November 20, 1987

Errata for U.S. Geological Survey Open-File Report 84-552 "Rock Property Measurements on Large-Volume Core Samples from Yucca Mountain USW GU-3/G-3 and USW G-4 Boreholes, Nevada Test Site, Nevada"

Open-File Report 84-552

Figure 12. Correlation between resistivity and porosity for the USW G-3/G-3 and USW G-4 sample data sets based on a least squares fit. The equation for the line of regression and the correlation coefficient,  $r$ , is indicated for each plot.

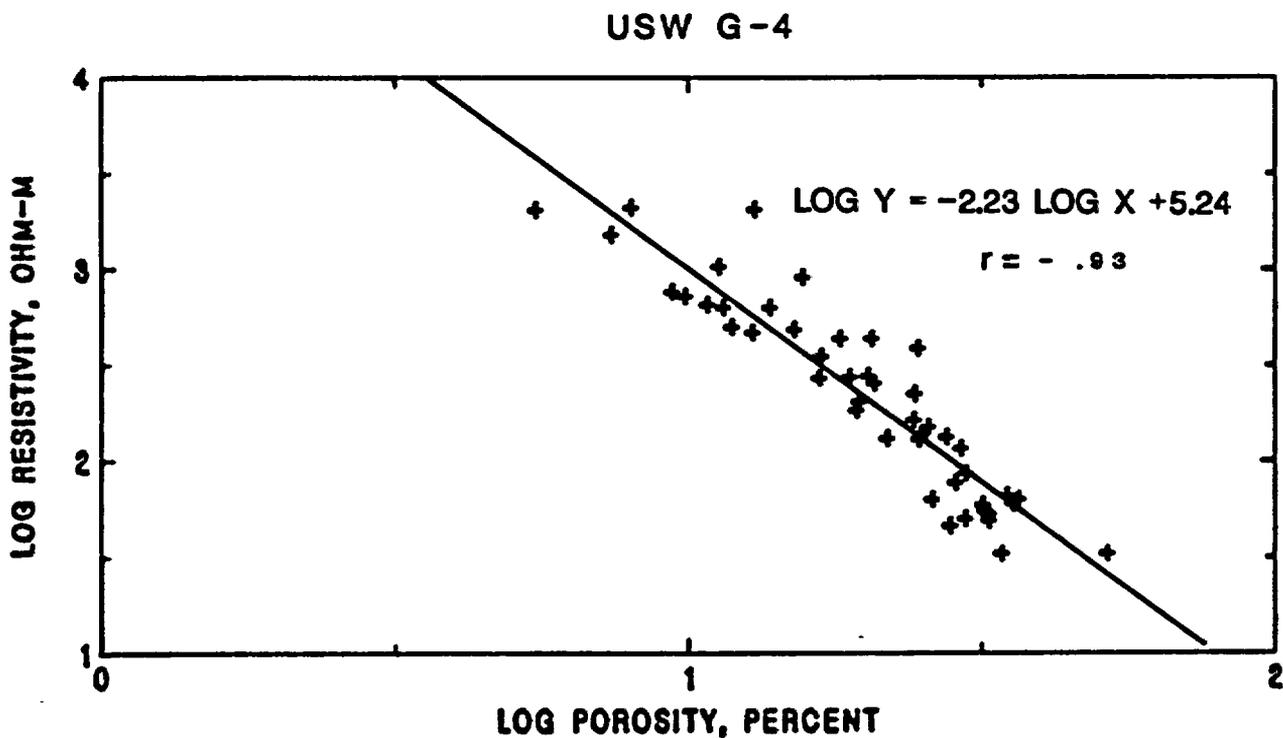
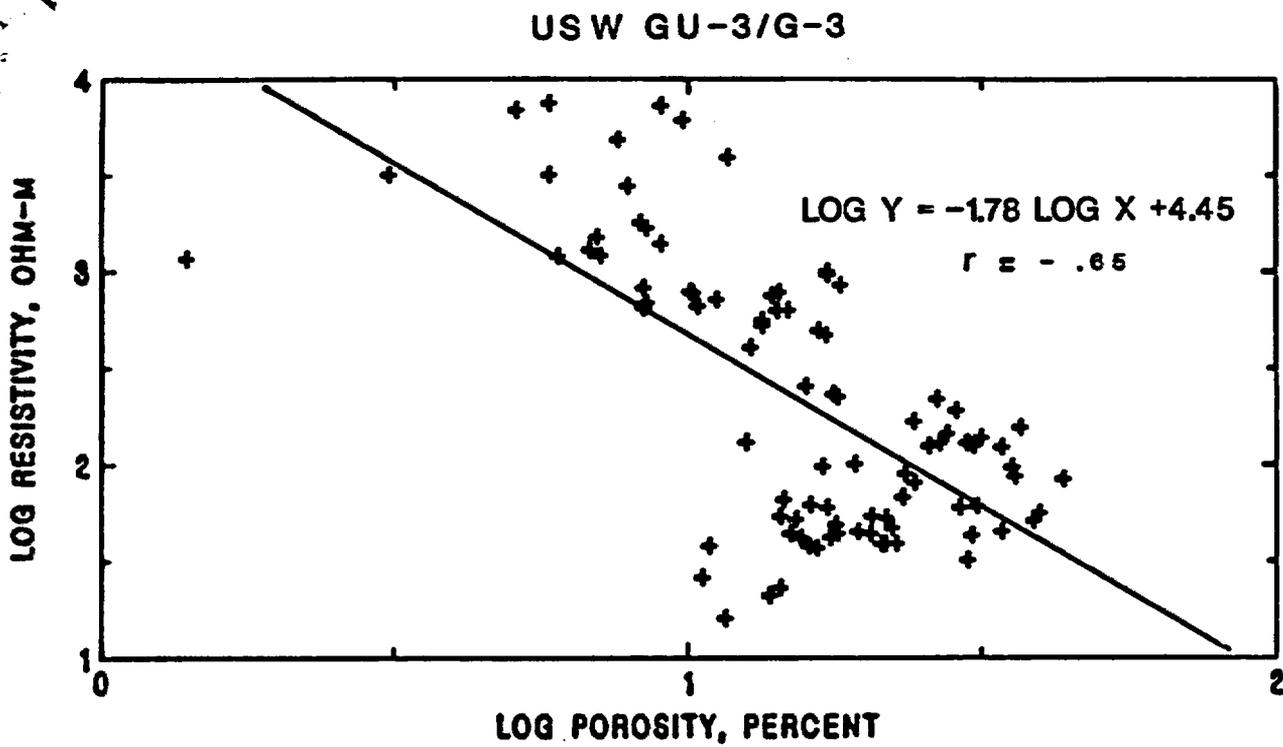
The equations shown on figure 12, page 37 of the report, are in error. The equation for the diagram for USW GU-3/G-3 should be changed from  $\text{LOG } Y = -1.78 \text{ LOG } 4.45X$  to  $\text{LOG } Y = -1.78 \text{ LOG } X + 4.45$ ; and the equation for USW G-4 should be changed from  $\text{LOG } Y = -2.23 \text{ LOG } 5.24X$  to  $\text{LOG } Y = -2.23 \text{ LOG } X + 5.24$ . A revised copy of the figure is attached.
